SUMMARY OF CONCERNS IN RELATION TO THE PROPOSED NORTHCONNEX TUNNEL

This is an objection to many aspects of the proposed NorthConnex tunnel.

SECTION A: THE CONNECTIVITY OF NORTHCONNEX SOUTHERN VENTILATION FACILITY AT THE SOUTHERN INTERCHANGE, THE SOUTHBOUND TUNNEL IN PARTICULAR

MOTORWAY OPERATIONS COMPLEX - SOUTHERN VENTILATION FACILITY - SECTIONS
M1-M2-5000-DR-JD-0525

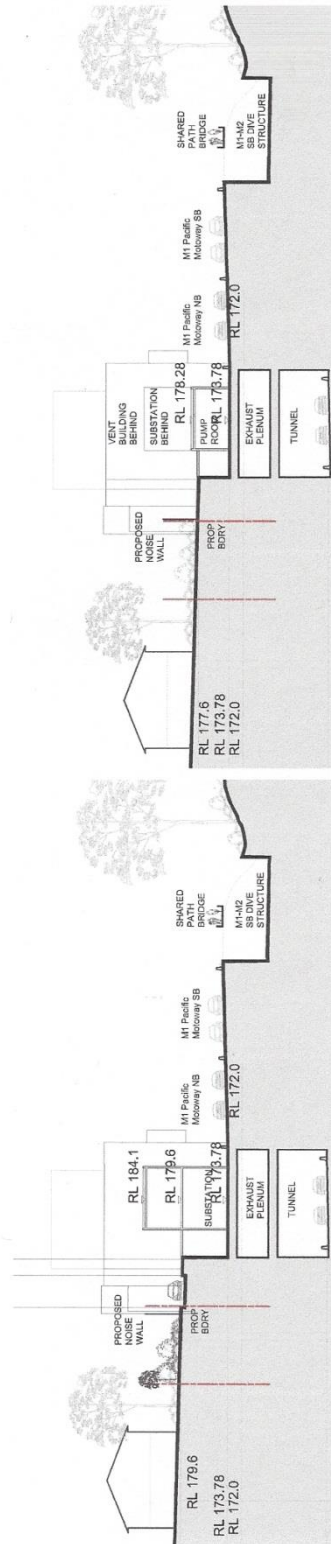
5. *EIS Volume 4, Technical working papers - Urban Design, 6.0 Operational Ancillary Facilities*
EIS Page 99 there is the diagram "Motorway Operations Complex – Southern Ventilation Facility – sections. *Page 10 below* The diagram has the cryptic label "Connection to tunnel TBC". What does TBC stand for? To be considered? Why is tunnel singular? Which tunnel is the diagram referring to northbound or southbound? There is no diagram showing any connection from the Southern Interchange ventilation facility to either the northbound or the southbound tunnel in any way AND YET

- Diagrams need to be provided showing the inter-relation between the shaft, the ventilation outlet and the motorway operations centre with a clear description of what is to be constructed and how it will operate.
- The community needs irrefutable evidence that the polluted air from the southbound tunnel exit portals will not be allowed to flow like an invisible sewer through West Pennant Hills, North Rocks, Carlingford and Beecroft.

M1-M2-5000-DR-UD-0550
NORTHERN VENTILATION FACILITY - CROSS SECTIONS

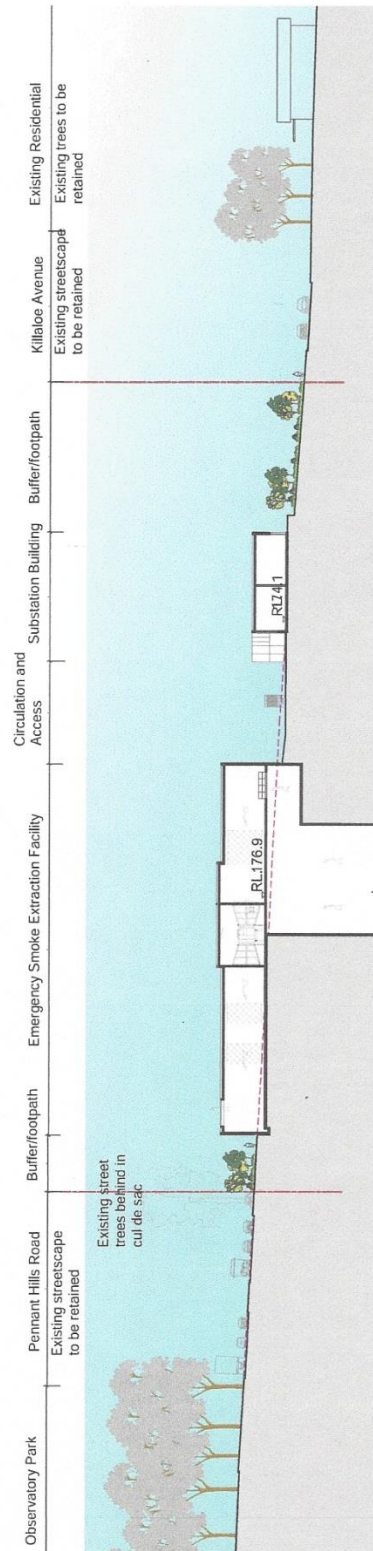
EIS page 135 *Page 11 below* there is a very explicit diagram showing the *Northern Ventilation Facility – cross section*.

Why are there no comparable diagrams for the Southern Interchange and the Southern Ventilation facility?
